Subject: Multiple planning applications for offshore wind farms.

In particular, I have been looking at the Vattenfall wind farm applications for Norfolk Vanguard and Norfolk Boreas, comparing these applications against Orsted Hornsea 3 wind farm application.

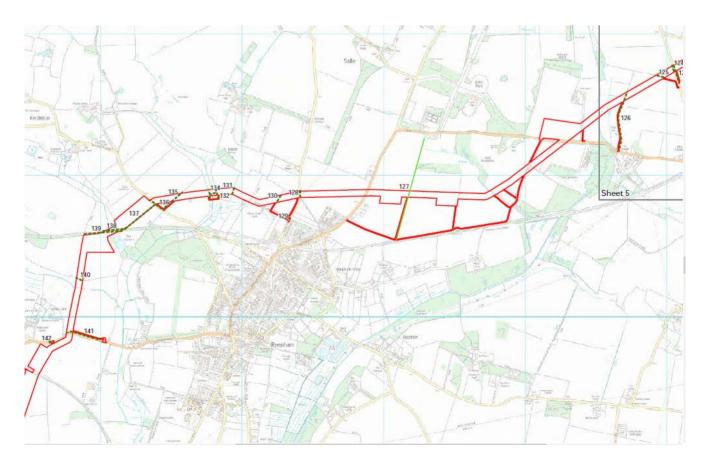
At just east of the town Reepham, Norfolk, there is going to be a massive problem, which neither applicant has taken into account, nor does it seem any of the registered interested parties.

The two cables are going to cross over each other, this is just not going to work. Not only is it physically near impossible to pass, it will not conform with any of the accepted standards for the cable laying procedures either intend to use.
